Avon Advisory Planning Commission Meeting
Monday, February 23, 2026 at 6:30 pm
at Avon Town Hall

Planning & Building Department Staff Report

Exhibit C – Planning TAC Letter (Page 1 of 4)

Exhibit B2 – Revised Proposed Site Plan (Received 2-Jan-2026)

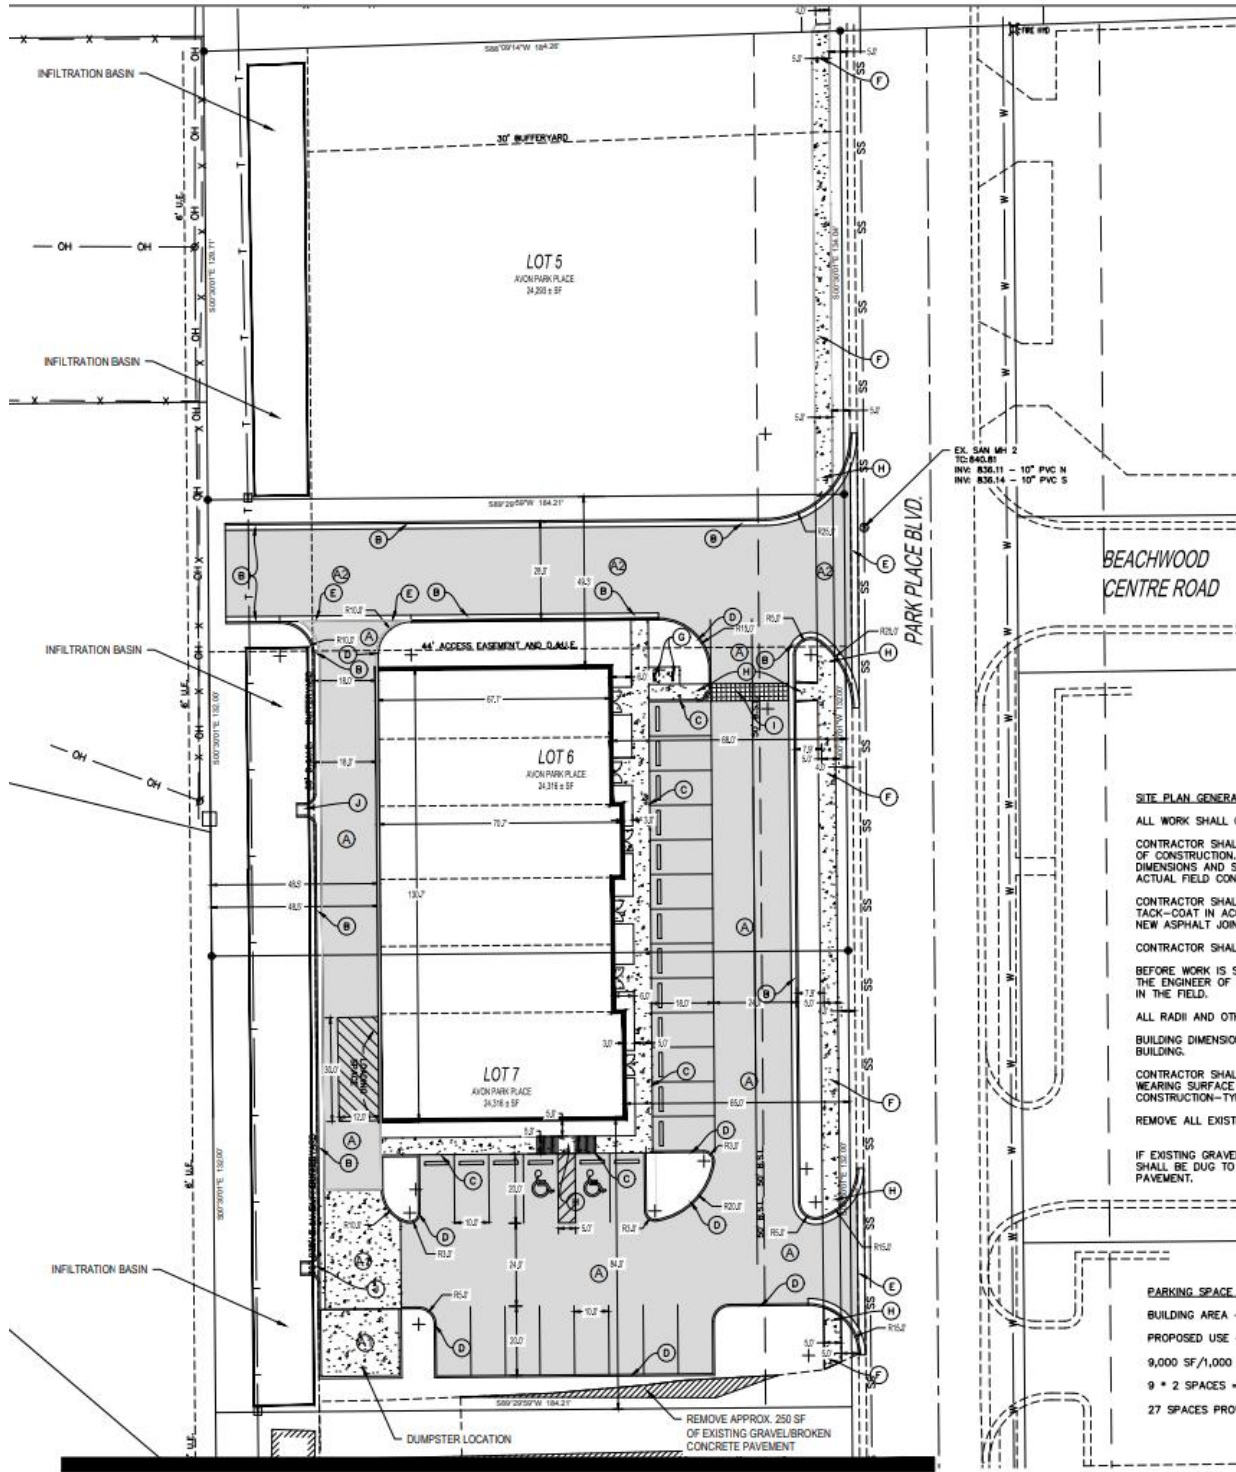
2. Per comments from the Department of Public Works and UDO 2.10(L), an extension of the business collector street (Beechwood Centre Road) identified in the Town of Avon Thoroughfare Plan must be constructed with development of this site. The site plan will need to be revised to relocate the proposed improvements to accommodate said street extension.

4. There appear to be discrepancies between the submitted site plan and building elevations in that the submitted building elevations appear to show six entrances on the east facade, but the site plan shows only four. Please make sure these plans match.

7. Per UDO 2.10(M)(1), a minimum 20' deep front yard landscape buffer is required. The submitted plans are deficient. Please revise plans accordingly or request a variance or waiver (if eligible).

8. Per UDO 6.6(C), one parkway tree is required to be planted in the right-of-way per 50 lineal feet of frontage. No parkway trees are indicated on the submitted landscape plan. Please revise the landscape plan accordingly.

9. Per UDO 2.10(M)(4) & UDO 6.7(C), two (2) shade trees per seventy feet of lineal feet of parking lot perimeter are required. This appears to require four trees along the east perimeter and six along the west perimeter, where only three and four respectively are shown on the landscape plan. Please revise the landscape plan accordingly.

10. Per UDO 6.7(C)(2)(b), a continuous dense hedge running the length of the parking lot is required abutting the west and north perimeters of the lot, and covering 75% of the east and south perimeters of the lot. Please revise the landscape plan accordingly.

11. Per UDO 6.8(D), a solid, year-round screen at least 8 feet high is required within the north and west buffer yards. A 6-foot high shadow box fence is proposed on the landscape plan. Please revise plans to indicate compliance with one or more of the options listed in UDO 6.8(D).

12. Per UDO Table 6.1, 90-degree angle parking requires 20-foot deep spaces, however, 18-foot deep spaces are shown in one of the rows. A variance or waiver can be requested, or the plans will need to be revised accordingly.

13. The application indicates that the building would be used for "office flex space". The closest match to this for purpose of parking requirements in UDO Table 6.3 would be "Office, All Others", which requires 2 spaces per 1,000 square feet of gross floor area, which would require 49 parking spaces for the proposed 24,293 square-foot building. Only 33 spaces are shown on the proposed plan. A variance or waiver can be requested or the plans will need to be revised accordingly, unless the proposed use of the building is revised.

14. Per UDO Table 6.5, one loading space would be required, which would need to be a minimum dimension of 12 feet by 30 feet, unless tractor-trailers would be servicing the site, and would need to meet the standards in UDO 6.13(C). Please revise plans accordingly.

15. Per UDO Table 6.4, a development providing parking spaces within a range of 26 to 50 must provide a minimum of two (2) accessible parking spaces meeting the standards of UDO 6.12(E). No such spaces appear to be indicated on the plans. Please revise the plans accordingly.

16. Per UDO 6.11(F), wheel stops are required adjacent to pedestrian walkways. Please revise plans accordingly.
17. Per UDO 6.11(G), all rows of parking must have terminal islands with a minimum width of eight (8) feet and a minimum area of 130 square feet. The terminal island at the north end of the parking in front of the building appears to measure ~ five (5) feet wide and ~ ninety square feet. Please revise plans accordingly.

18. Per UDO 6.11(D)(3), the first twenty (20) feet of a drive must be kept free from parking maneuvers. The parking space at the southeast corner of the site would violate this requirement. Please revise plans accordingly.

19. Per UDO 6.5(A), a minimum five (5)-foot wide landscaped strip is required around the perimeter of all principal buildings exclusive of doorways and loading areas. The west façade and portions of the east façade do not appear to meet this requirement. Please revise plans accordingly.

20. Per UDO 6.12, a minimum of two bicycle racks meeting the standards listed therein must be provided. Please revise plans accordingly.
21. Per UDO 7.19 and UDO 2.10(J), the development must integrate the interior and exterior pedestrian network through means of a safe dedicated pedestrian connection between the public sidewalk and the building, and where said connection crosses driving surfaces it must be distinguished therefrom through means of low maintenance materials such as pavers, bricks, or scored/stamped concrete or asphalt. Please revise plans accordingly.

Exhibit B – Revised Site Plan (5-January-2026)

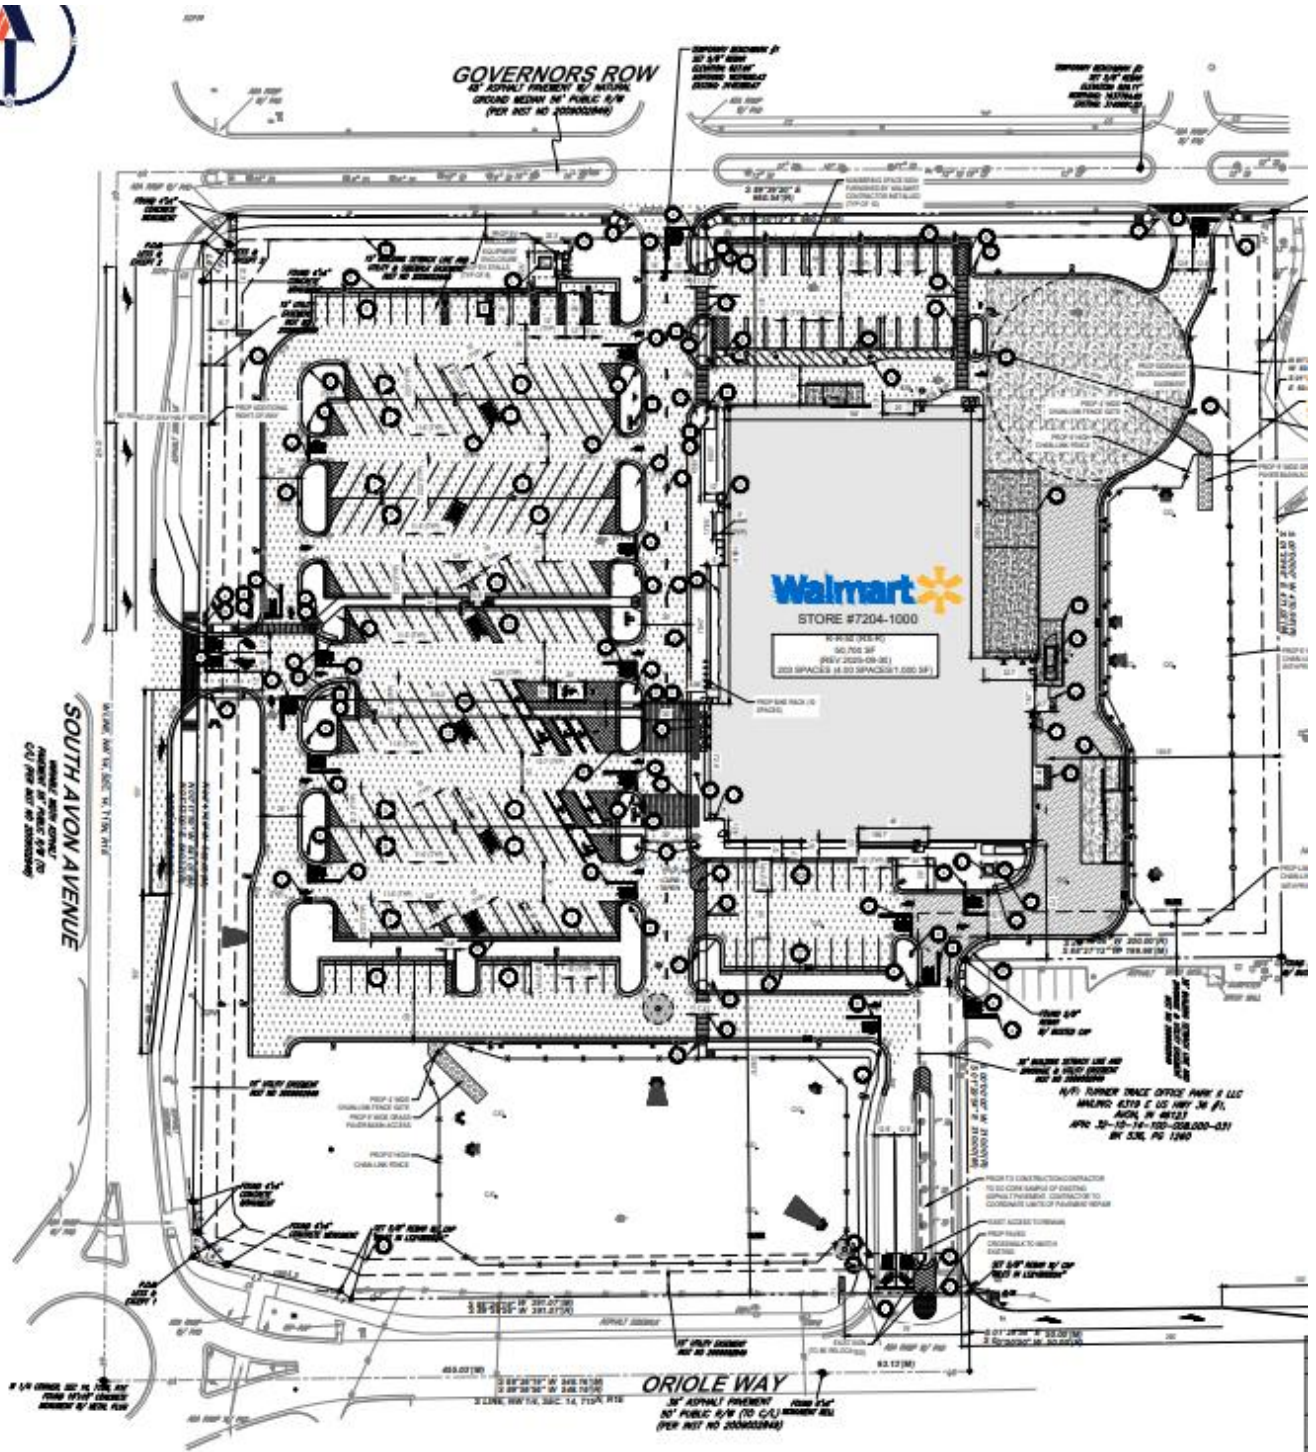
a) **Parking:** The site plan indicates the provision of 225 off-street vehicle parking spaces, with eight (8) of those being reserved accessible spaces. UDO Table 6.3 specifies that a minimum of 2.5 spaces per 1,000 square feet of gross floor area for a grocery store or other retail use, thus, a minimum of 127 spaces would be required for the proposed 50,700-square foot store. Based on the overall number of spaces provided, a minimum of seven (7) reserved accessible spaces would be required.

b) **Loading:** Retail buildings between 7,500 and 75,000 square feet are required to provide a minimum of one (1) dedicated loading space. The site plan indicates two (2) dedicated loading spaces meeting the spatial requirements for tractor-trailer deliveries.

revised site plan shows bicycle racks in a compliant location, the plan only indicates five racks. At least one additional rack would be required.

Exhibit C2 – Areas Deficient of Foundation Planting Requirement

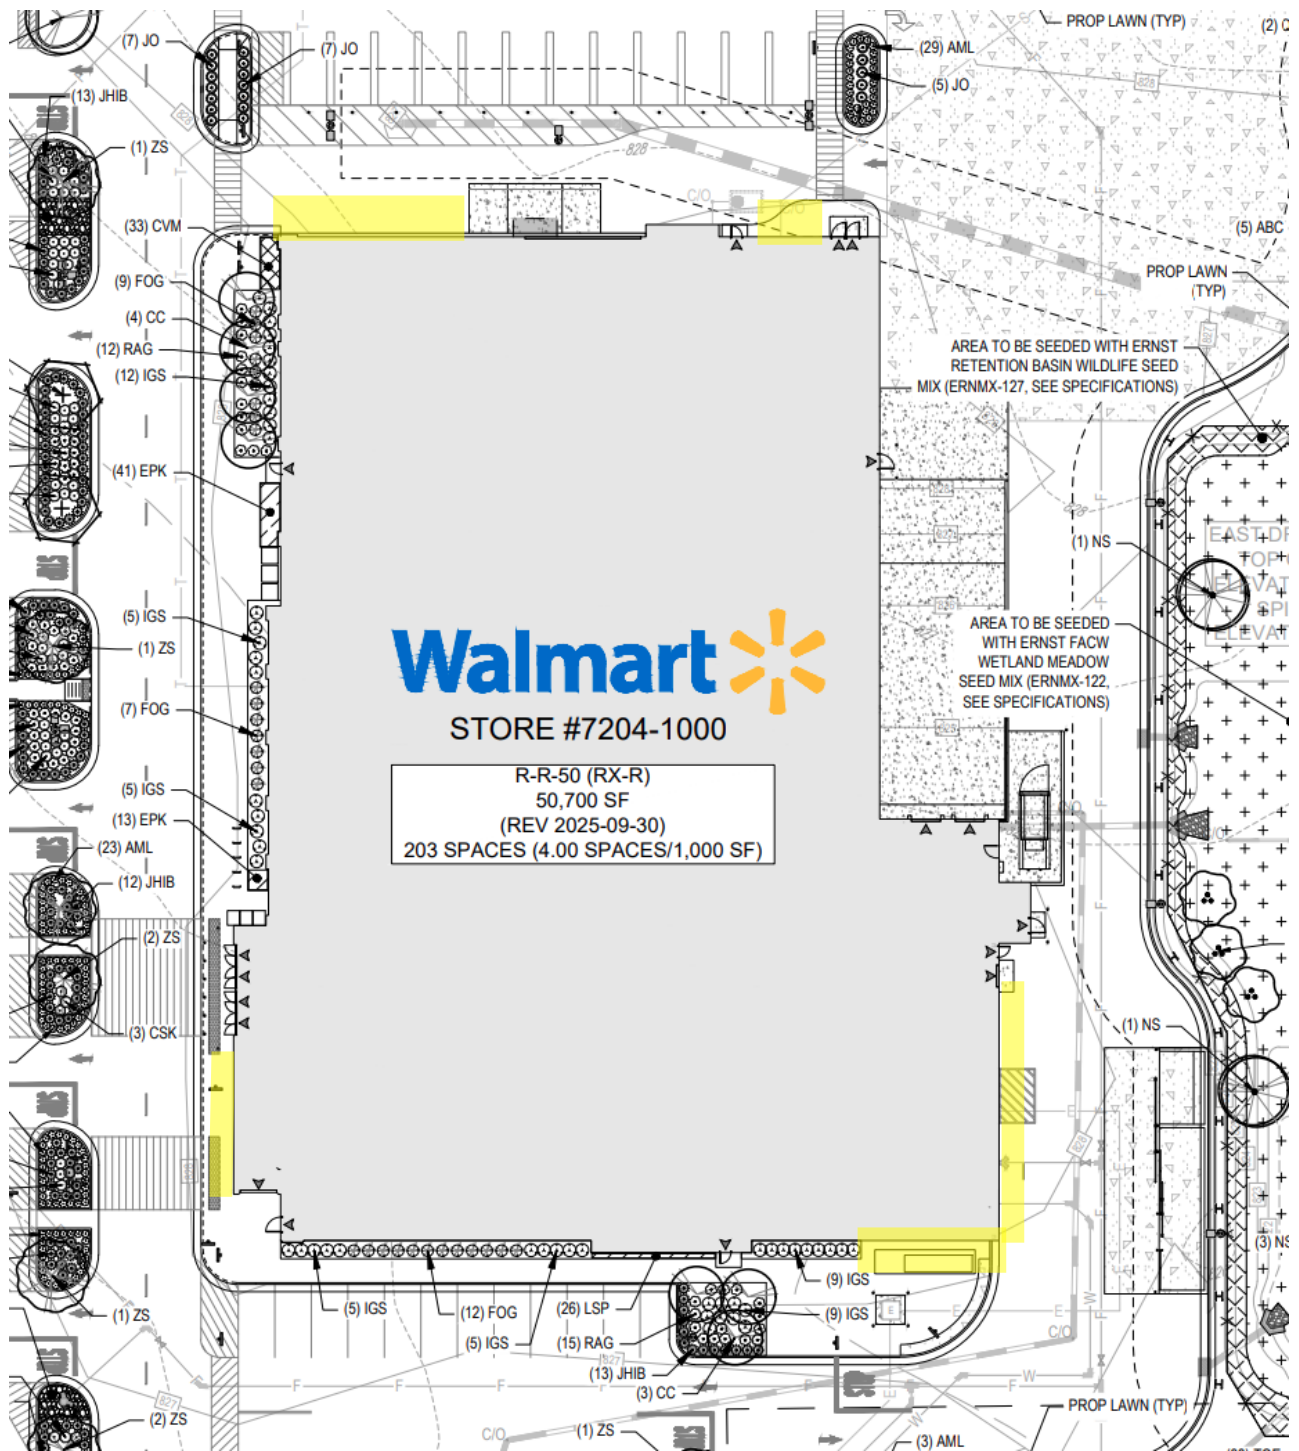
Per UDO 6.5 (A), a minimum five-foot planting area must be provided around the perimeter of the building, excluding access to the buildings, such as loading areas and doorways. The landscape plan submitted subsequent to TAC review has increased the proposed foundation planting areas, but is still deficient along several portions of the building (see Exhibits C1 & C2).

Per UDO 6.7(B)(4), each parking lot landscape island must have a minimum of one tree. The revised landscape plan is still deficient of this standard.

A further revised landscape plan should be submitted to demonstrate compliance with the foundation planting and interior parking lot landscaping requirements.

2. Prior to issuance of a building permit, a revised landscape plan shall be submitted, requiring approval by the Administrator, indicating compliance with all landscaping standards of the UDO.

Exhibit E – Aerial Photo w/ Measurements of Proposed Driveway Separation

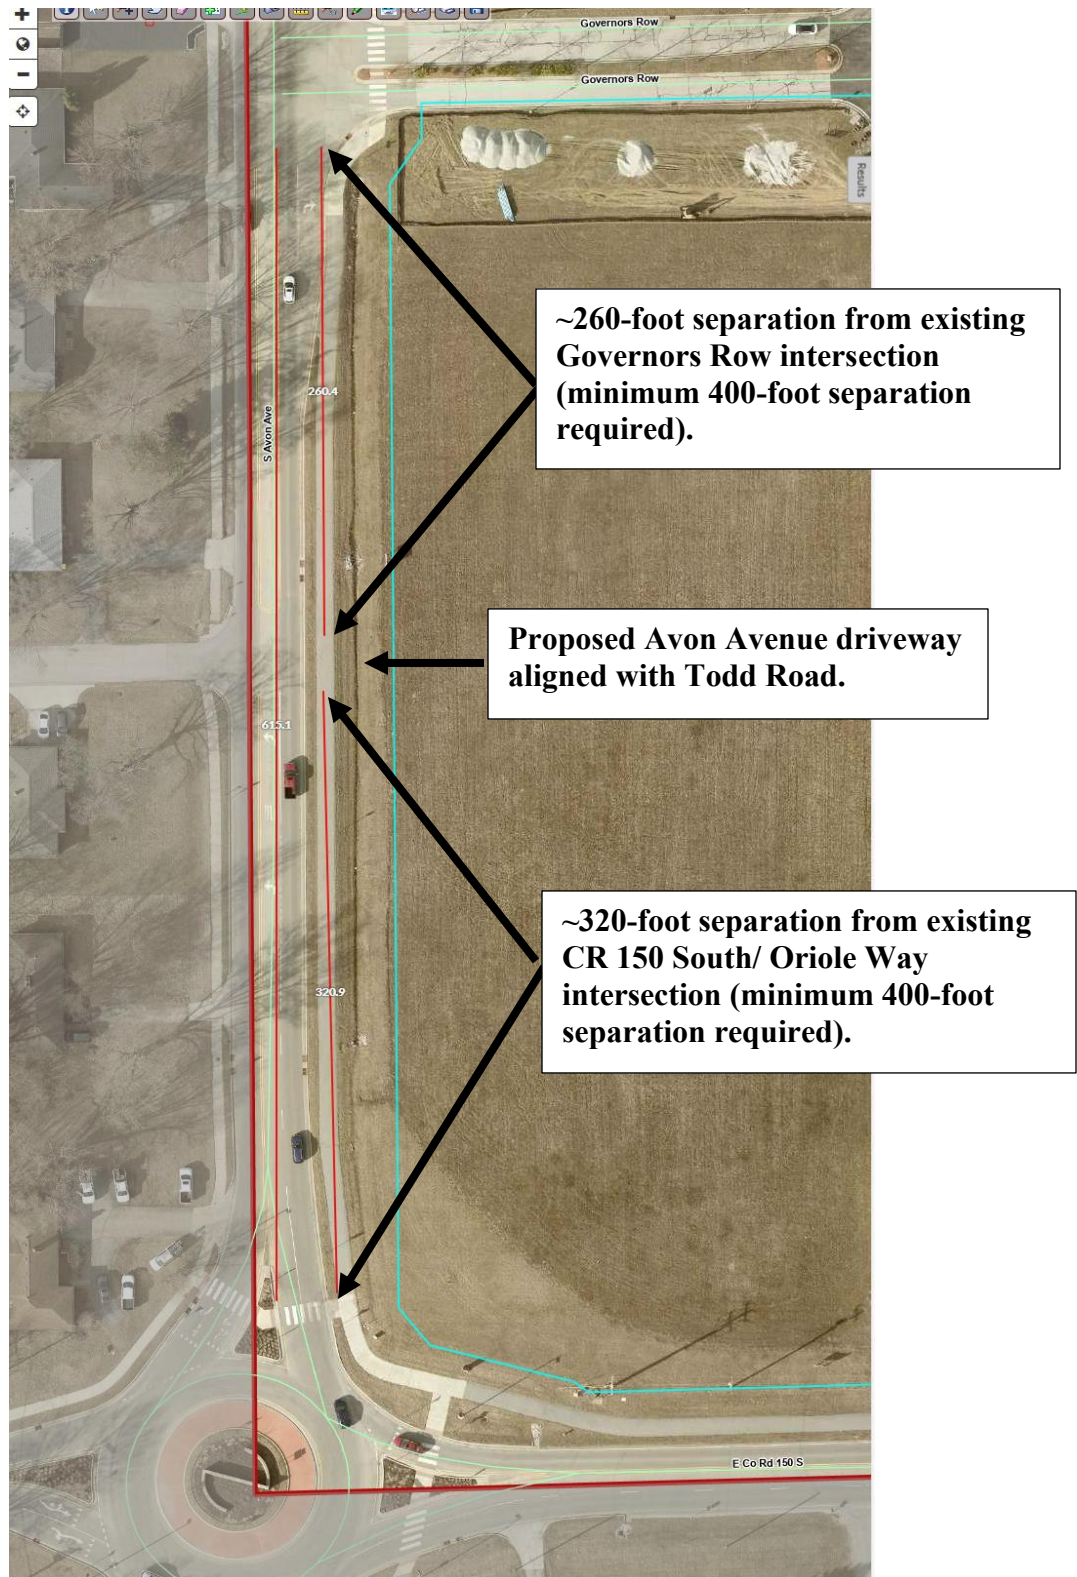
After evaluating the proposed development plan, the petitioner's TIS, and comments from the Town's consulting traffic engineer and Public Works Director, the Town opposes the requested waiver for direct access to Avon Avenue (see Exhibits E & G), and the Town has determined that the property owner should construct the following necessary improvements concurrently with development of the site.

While the property's frontage is not lengthy enough to meet the separation standards for a new direct access point to Avon Avenue, the site is already served by driveways onto County Road 150 South/ Oriole Way and onto Governors Row, both of which provide full access to/from Avon Avenue.

Petitioner's response: "the ordinance requires 400 feet of separation, however a 35% reduction of the 400 feet, to 260 feet, is permitted via a waiver. The proposed plan provides a separation distance between intersections over 260 feet."

Petitioner's response: "the subject property's size and shape limit the ability to achieve the 400-foot separation without creating significant design challenges such as encroaching into the adjacent roundabout intersection."

Petitioner's response: "the positioning of this access aligns with the existing Todd Road intersection on South Avon Avenue. Aligning intersections is typically desired and is generally accepted engineering practice."

Exhibit D – Building Elevations Building A

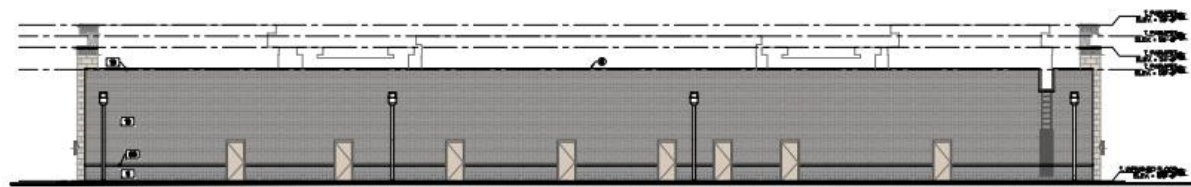
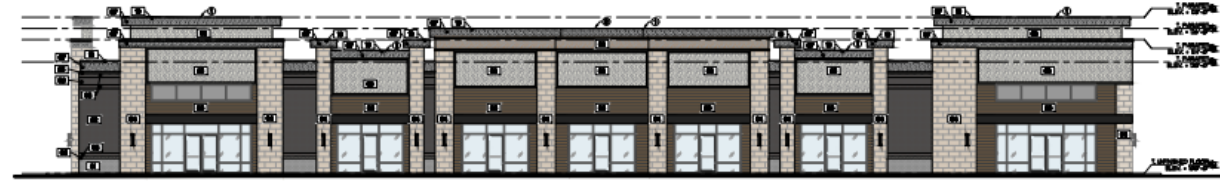
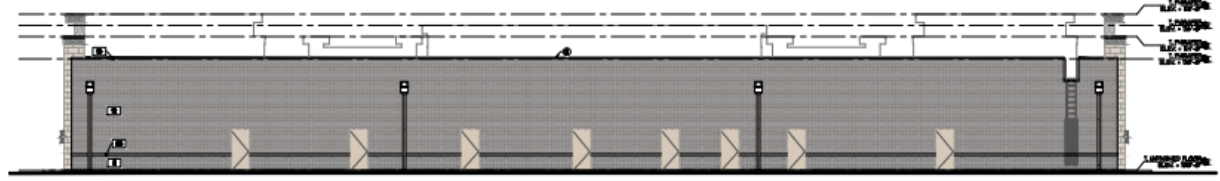
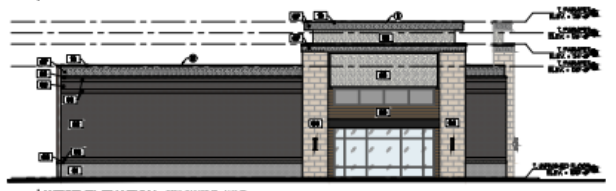
The proposed percentage of brick ranges from 36% on the front façade to 97% on the rear façade. Therefore, the overall appearance of the buildings will meet the intent of the UDO for having high-quality materials. While the front façade does not meet the 80% requirement, the change of materials offers a superior visual interest to warrant a deviation from the brick standard.

Petitioner's response: "this design improves upon the aesthetics of the surrounding area and uses high quality finishes, including: brick, cast stone, Nichiha panels and EIFS accents."

Petitioner's response: "it is keeping/improving upon the character of the area, and abides by the UDO's design quality intent, while also providing signage area above each tenant to allow ease of modification and maintenance through material selection, creating a better-looking façade over time."
